STATE OF VERMONT AGENCY OF TRANSPORTATION

PROPOSED IMPROVEMENT BRIDGE PROJECT TOWN OF HARTLAND COUNTY OF WINDSOR

RECORD PLANS	
CONTRACTOR:	KUBRICKY CONSTRUCTION CORP. - WILTON, NY
RESIDENT ENGINEER:	DARYL BASSETT
CONSTRUCTION BEGAN:	JUNE 10, 2014
CONSTRUCTION COMPLETE:	NOVEMBER 5, 2014
RECORD PLANS BY:	DARYL BASSETT & KEVIN KING
I HEREBY CERTIFY THAT ALL THE CONSTRUCTION REQUIRED BY THIS SET OF DRAWINGS HAS BEEN ACCOMPLISHED AS INDICATED HEREIN.	
BY	RESIDENT ENGINEER
DATE	2/22/16
NOTE: Any further information concerning final quantities, amounts or other details relative to this project may be found by contacting Vtrans Records Management.

US ROUTE 5 (MAJOR COLLECTOR), BRIDGE NUMBERS 62A AND 66

TYPICAL CANTILEVERED WINGWALL SECTION  
SCALE 1/2" = 1'-0"

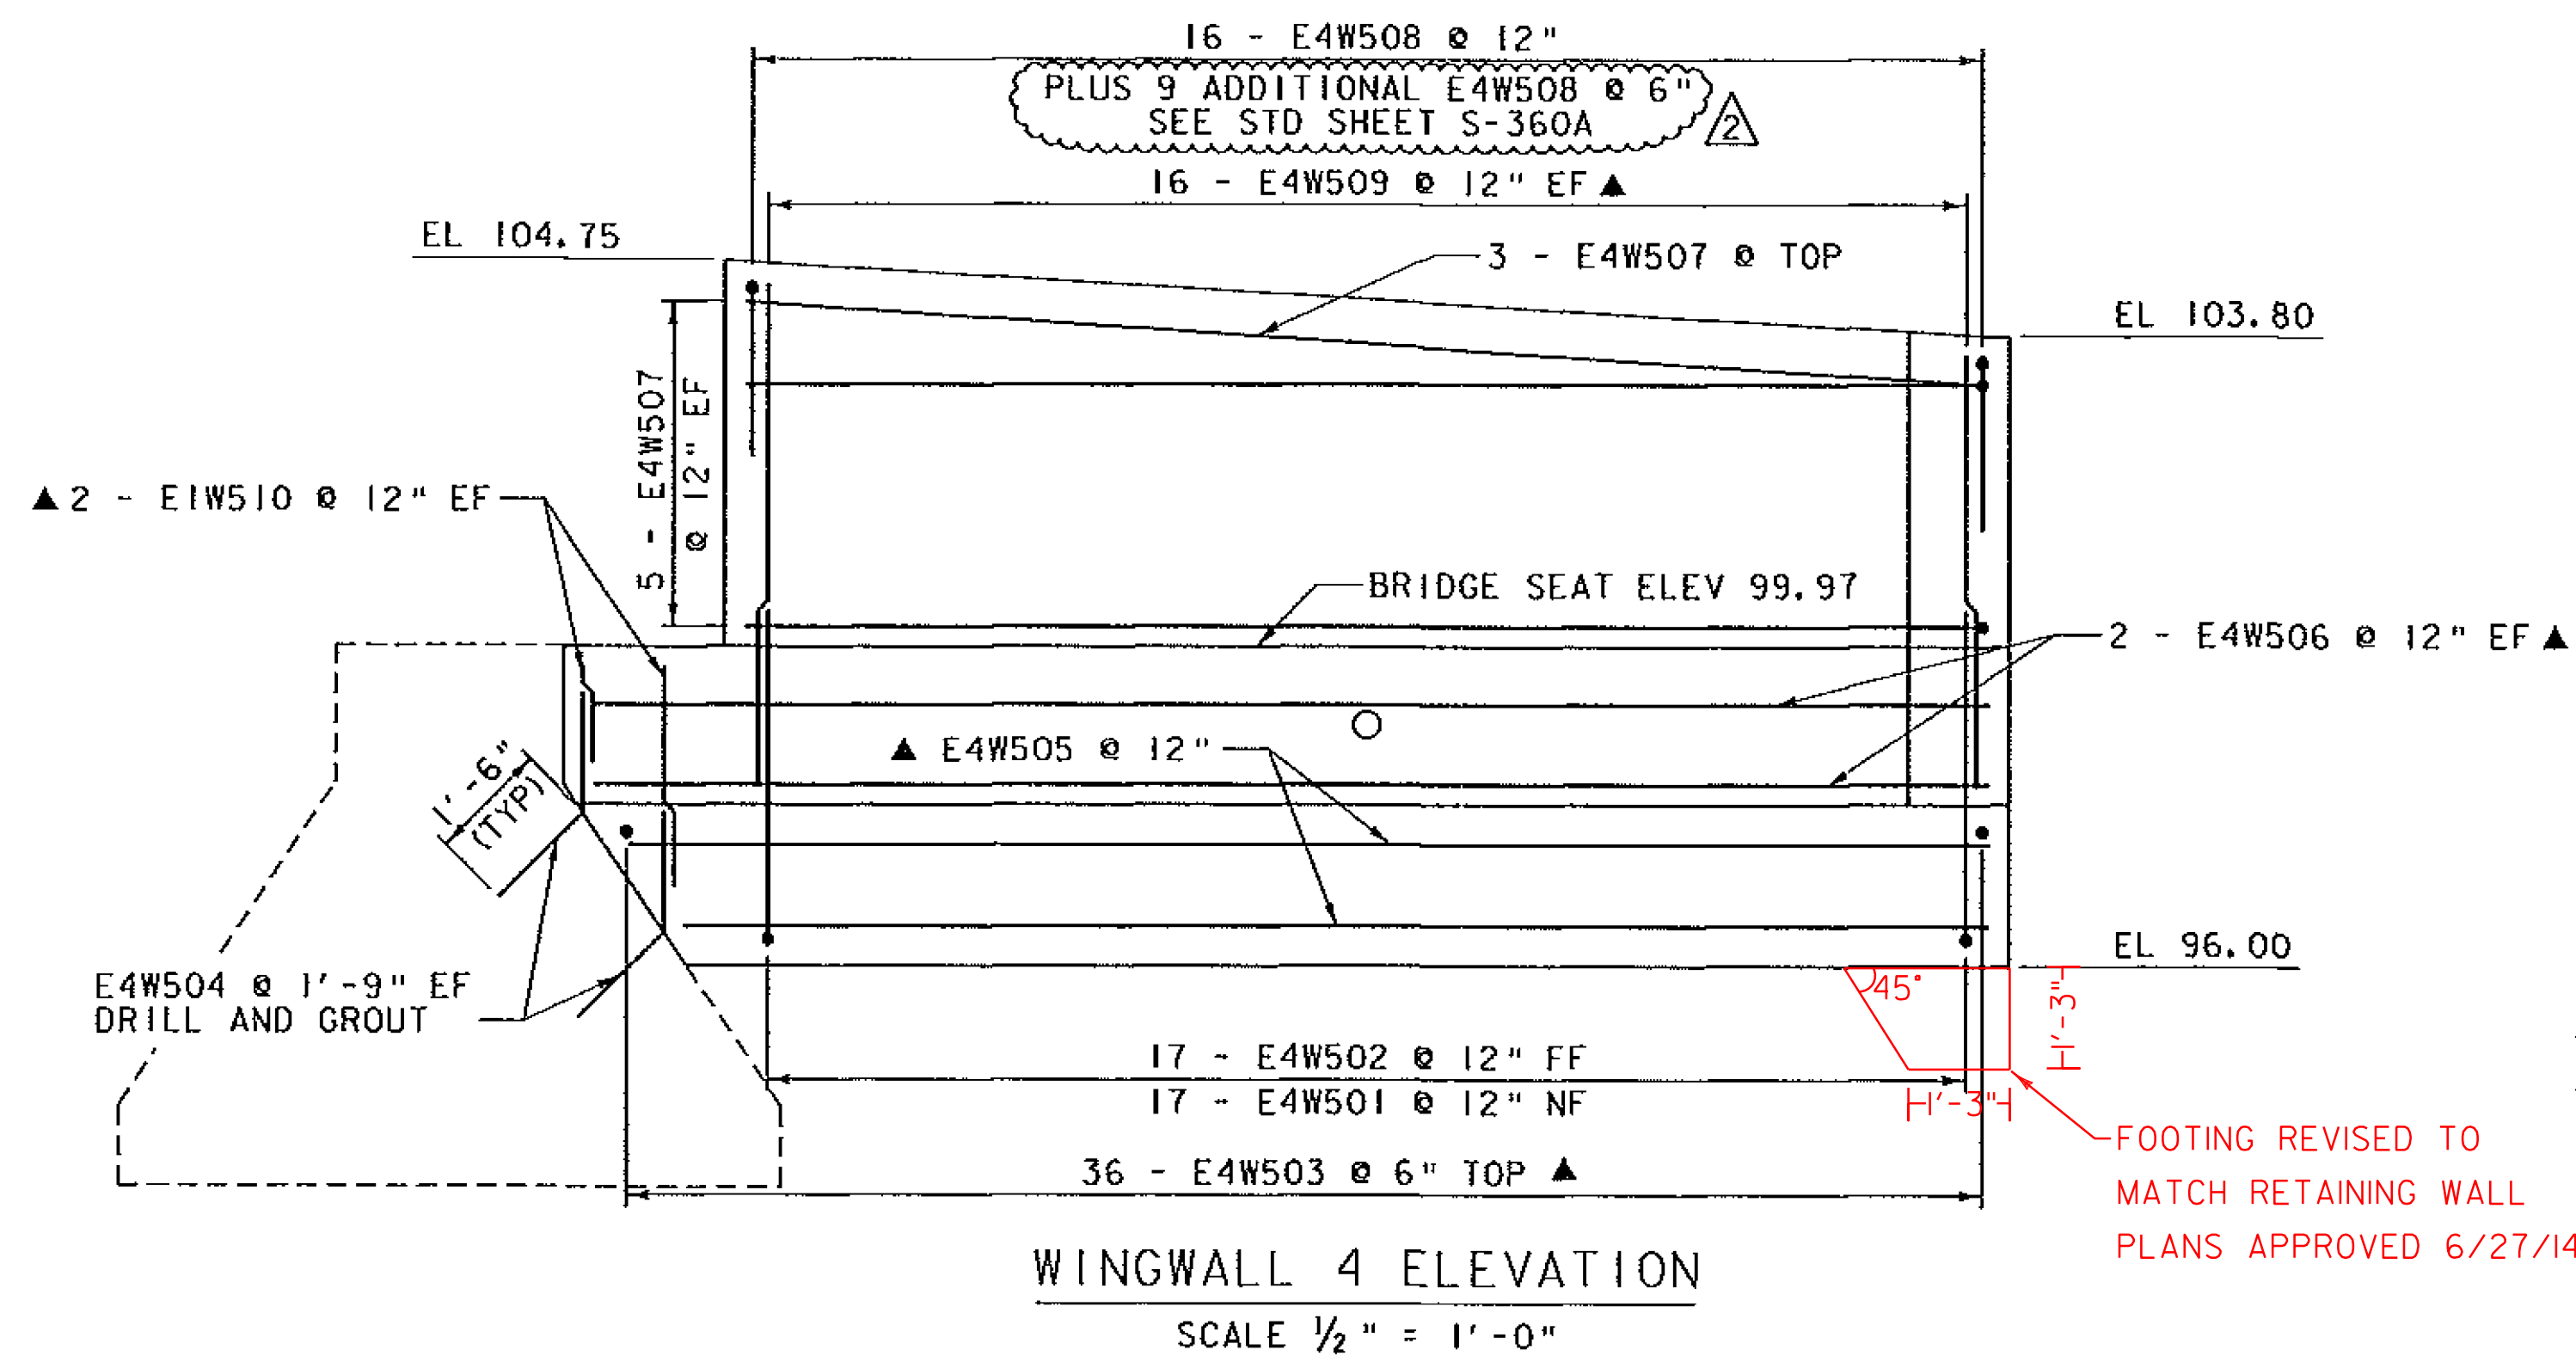
REV.	DESCRIPTION	DATE
△	ADDITIONAL EW508 AT POSTS	3/3/2014
PROJECT NAME: HARTLAND		
PROJECT NUMBER: BHF BPNT(12)		
FILE NAME: zllc260sub.dgn		PLOT DATE: 3/3/2014
PROJECT LEADER: M.A. COLGAN		DRAWN BY: A.J. GOUDREAU
DESIGNED BY: A.J. GOUDREAU		CHECKED BY: S.G. FARNSWORTH
BR 62A WINGWALL DETAILS (2 OF 2)		SHEET 29 OF 55
